CIVIC DESIGN REVIEW

Germantown
Apartments

Civic Design Review Key Recommendations to Guide Second Submission

Project Address and/or Title: 6225 Germantown Avenue

STREET VIEW RENDERING
(Germantown Ave.)

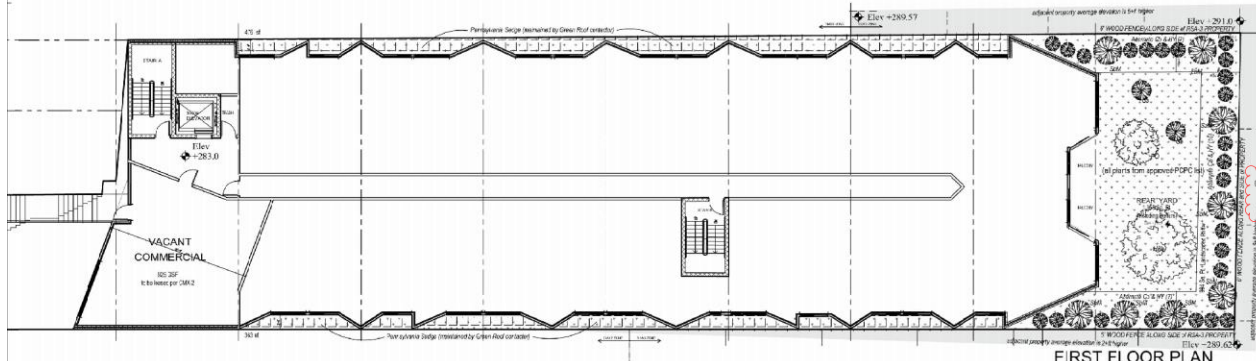
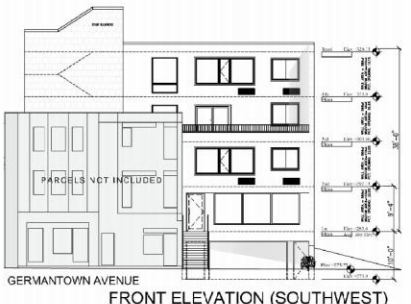
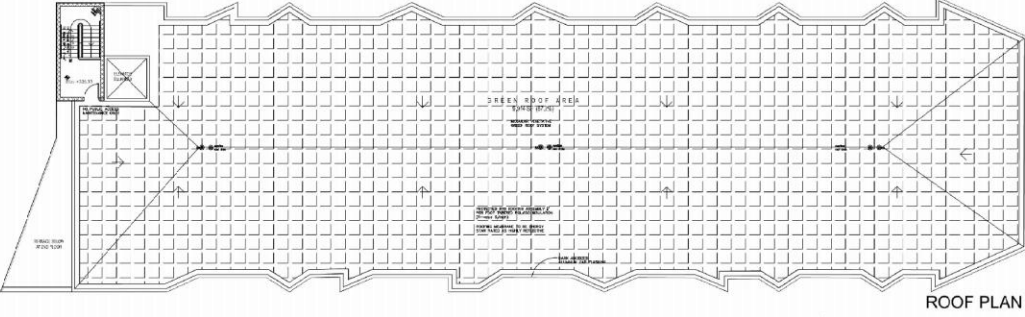
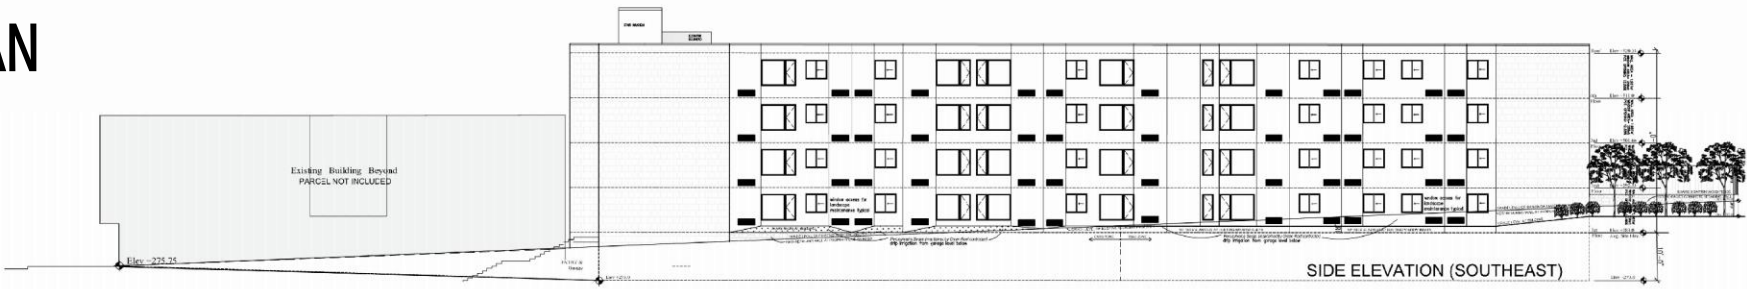
5 The sidewalk and driveway into the building is unwelcoming and narrow.

- Design the driveway as a shared pedestrian and auto space.
- It could be used to manage stormwater.
- Reconsider the fence along the property line. It is adding to the unwelcome nature of the entrance.

Fencing was revised to have a warmer and more welcoming look. Points were removed from the fencing and hanging planters were added to the fence to create a warmer look.

The driveway is part of the stormwater management and will utilize porous paving blocks, which will have a more ornate look and a lighter grey coloring unlike black asphalt. The rendering is updated to show this change.

6225 Germantown Ave.
Garage Plan

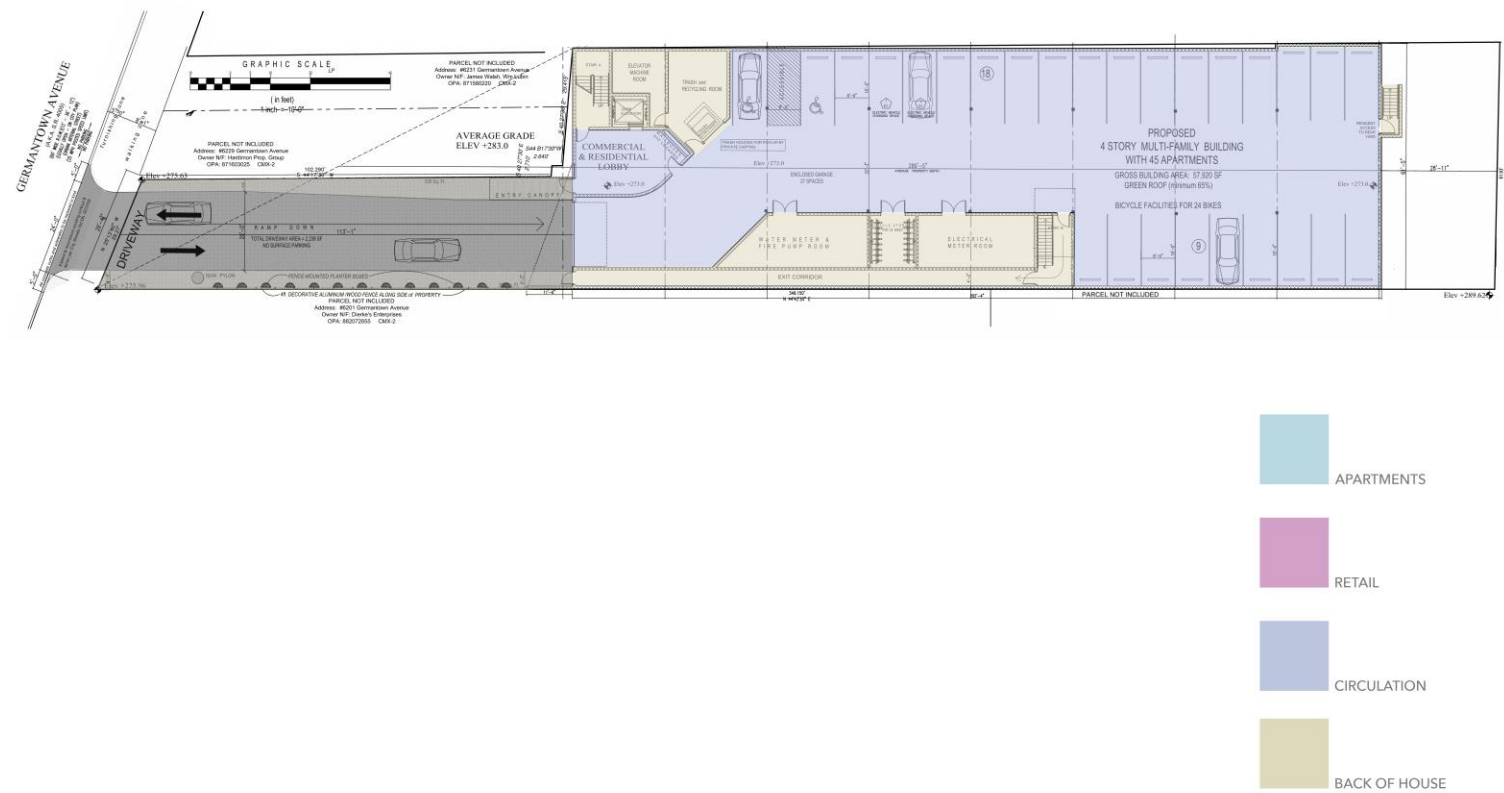
8 Consider moving the bike parking closer to the lobby.

The bike room was moved from the rear of the garage to the middle, but needed to account for mechanical room constraints, preventing it from being brought closer to the entrance.

FLOOR ELEVATIONS

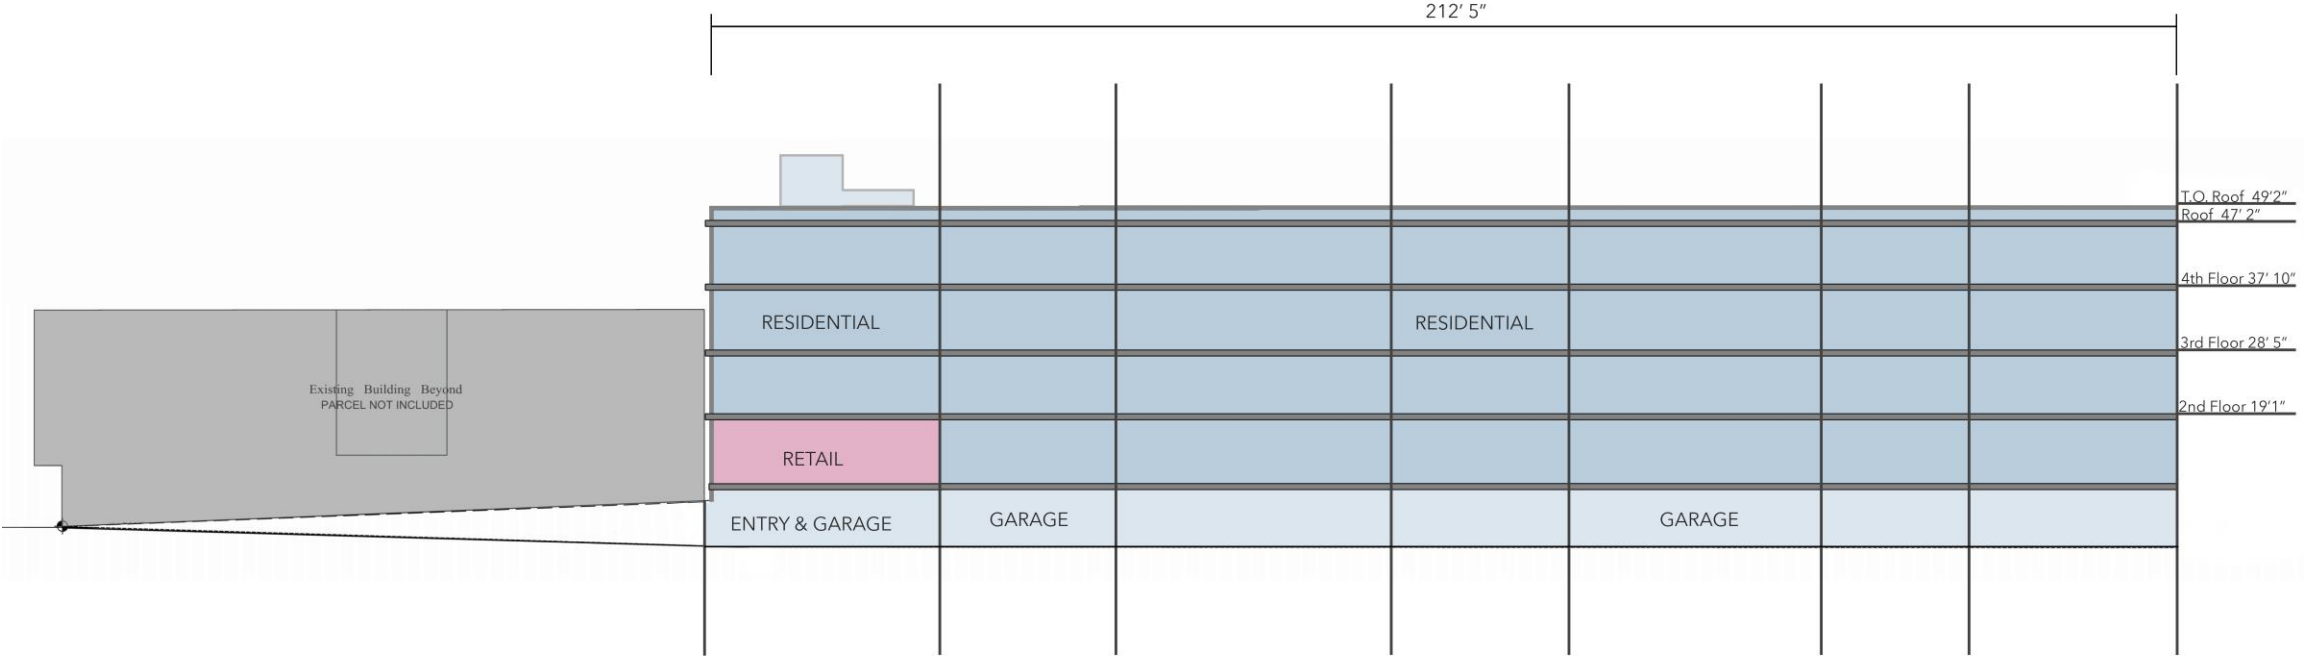
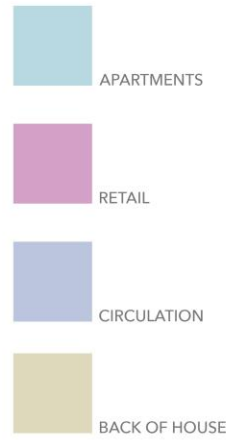
13 Consider ways to make to front facade to have more hierarchy.

Changes were made to the front façade to highlight the commercial retail space with paneling and brick and stone.
